APPLICATION NO.	FILING DATE	FIRST NAMED INVENTOR	ATTORNEY DOCKET NO.	CONFIRMATION NO.
10/509,650	04/29/2005	David Gomez Camara	GOMEZ CAMARA ET AL 1 PCT	2276
25889	7590	04/30/2008	EXAMINER	
COLLARD & ROE, P.C. 1077 NORTHERN BOULEVARD ROSLYN, NY 11576			KELLER, MICHAEL J	
			ART UNIT	PAPER NUMBER
			4136	
			MAIL DATE	DELIVERY MODE
			04/30/2008	PAPER

Office Action Summary	Application No. 10/509,650	Applicant(s) GOMEZ CAMARA ET AL.	
	Examiner Michael J. Keller	Art Unit 4136

DETAILED ACTION

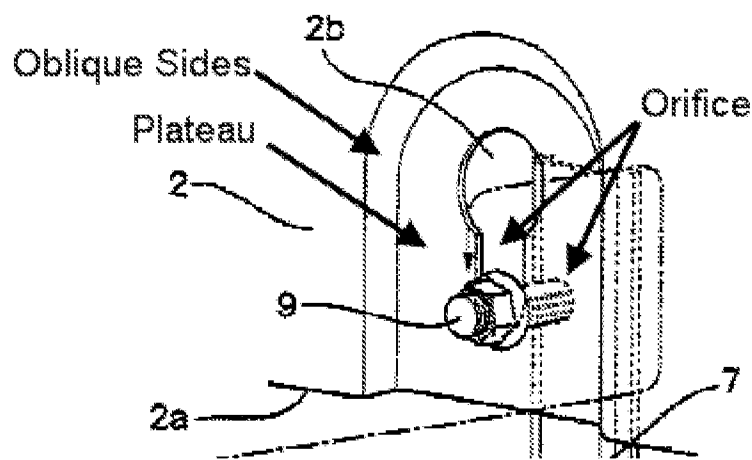
U.S.C. 102(b) as being anticipated by Morrison et al. (US 2001/0038228). Morrison et al. discloses [claim 1] a supporting module with waterproof seal for vehicle doors with a cable window lift mechanism (102, Fig. 12), characterised in that it consists of a

flexible laminar element (26) to separate the wet area from the dry area of the door and seal the mounting accesses to the inside of the door, which bears during the mounting operations on the door at least the window lift mechanisms and a support spacer (34, Fig. 6) allows a structural attachment of the door handle (56) and the door itself, so that when the aforementioned flexible laminar element is positioned on the door all the remaining components are placed in their mounting position, and once these elements are definitively attached to the door the loads to which they are subjected during their use are transmitted only to the door itself; **[claim 2]** characterised in that the support spacer is integrated in the flexible laminar element forming a single body with it (see Fig. 6); **[claim 3]** characterised in that it incorporates a loudspeaker (86, Fig. 8); **[claim 4]** characterised in that it incorporates the lock and at least the transmission mechanisms for the locking, opening and closing actions (36, Fig. 6); **[claim 7]** characterised in that it includes electrical cables for a window lift motor (Paragraph 48); **[claim 8]** characterised in that it incorporates electrical accessories (Paragraph 48); **[claim 9]** characterised in that the flexible laminar element provides an acoustical insulation function (any sound passing through the metal or polymeric material of the element would be dampened) **[claim 10]** characterised in that the waterproof seal of the flexible laminar element establishes a waterproof seal on the door by means of a peripheral sealing gasket (42, Fig. 2) that adapts to the surface and outline of the space of the door; **[claim 12]** characterised in that the waterproof seal between the flexible laminar element and the access openings (35, Fig. 4) for assembling the components is established by closures or lids (40); **[claim 13]** characterised in that the closures or lids

sealing the assembly access openings are included in the flexible laminar element; **[claim 14]** characterised in that the seal between the flexible laminar element and the components and accessories that must cross from the wet to the dry area and vice versa is established by sealing gaskets (74, Fig. 8); **[claim 15]** characterised in that the sealing gaskets for the components and accessories that must cross from the wet to the dry area and vice versa are included in the flexible laminar element; **[claim 17]** characterised in that it is provided with attachment means for the cabling incorporated in the flexible laminar element to form a single part with it (the cables of the window regulator are connected to the module by the lifting rails).

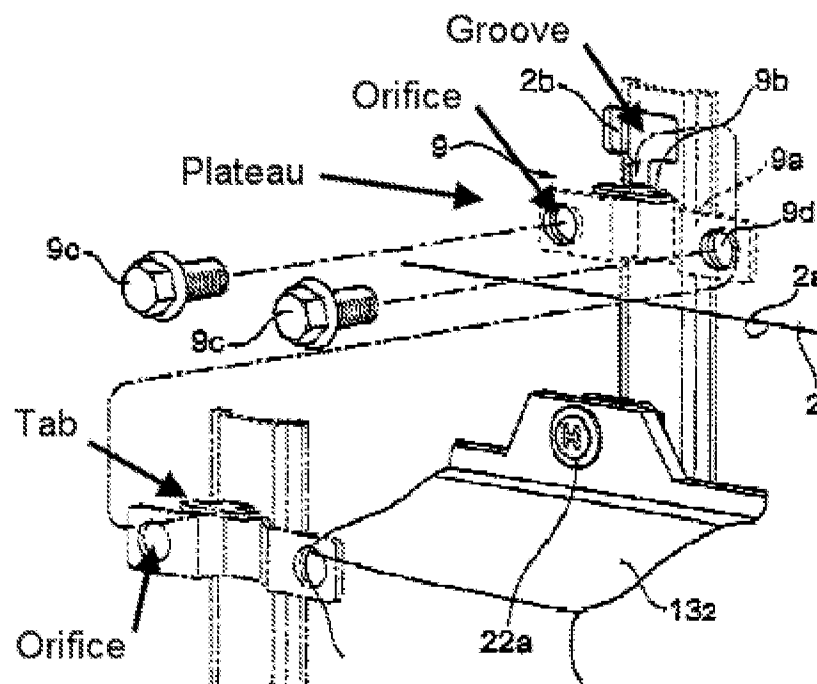
body with it (see Fig. 1); **[claim 3]** characterised in that it incorporates a loudspeaker (see Fig. 1); **[claim 5]** characterised in that the flexible laminar element incorporates the configuration of the base of an object-carrying pouch (21, Fig. 2); **[claim 16]** characterised in that the flexible laminar element is attached by attachment clips integrated in the flexible laminar element (see Fig. 9); **[claim 18]** characterised in that the window lift rails have self-centering and attachment means on the upper ends and lower ends (see Fig. 7 & 13); **[claim 19]** characterised in that the attachment and centering means consist of a groove (2b, Fig. 7) on the fixed support or door that is wider on one end of the groove and narrower on the other end, with a converging transition to house a thickened widening (9), on the end of the rail; **[claim 20]** characterised in that the centering and attachment means consist of a plateau with oblique sides on the fixed support or door on which rests the end of the rail according to a configuration that coincides in its shape and size with the aforementioned plateau of the door, such that an orifice coincides with the orifice of the plateau for a bolted union (see figure below);

[claim 21] characterised in that the centering and attachment means consist of a plateau on the fixed support or door with an orifice (9d) for a bolted union and a groove (2b) that is wider on one end than on the other, having a converging transition, and a tab (9b) and an orifice (9d) in the rail, such that the tab of the rail is made to coincide in the groove of the door until the orifices of the rail and the door coincide (see figure below); **[claim 22]** characterised in that the centering and attachment means consist of a grooved housing (2, Fig. 7) for guiding an attachment means, preferably a bolt (9), to a final position of the grooved housing where it is widened in order to maintain a stable position of the attachment means for a subsequent tightening.
